TAP CHANGER D.O.

B.H.E.L. BHOPAL

DOUBLE CLAMP

5055870:00/KS 126

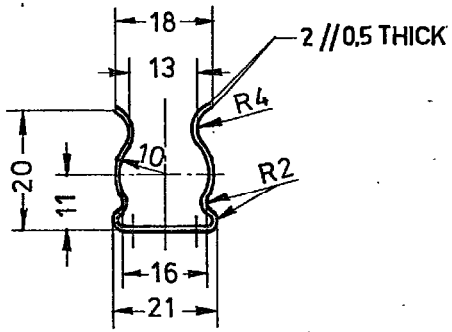
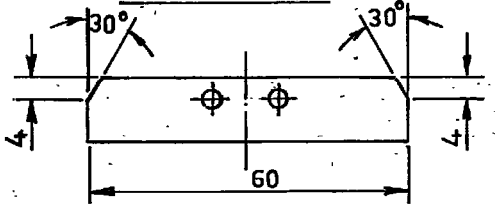
NOTE "RESISTIVITY UP TO 0,17 Ω-mm²/m IS ACCEPTABLE" ADDED.

MAT. WAS HALF HARD PHOSPHOR BRONZE STRIP BP12197 WAS BP12196.

- RESISTIVITY UP TO 0,17 Ω-mm²/m IS ACCEPTABLE.

0,5 TK. x 11,5 x 60 LG. PHOSPHOR BRONZE STRIP EXTRA HARD BP12197
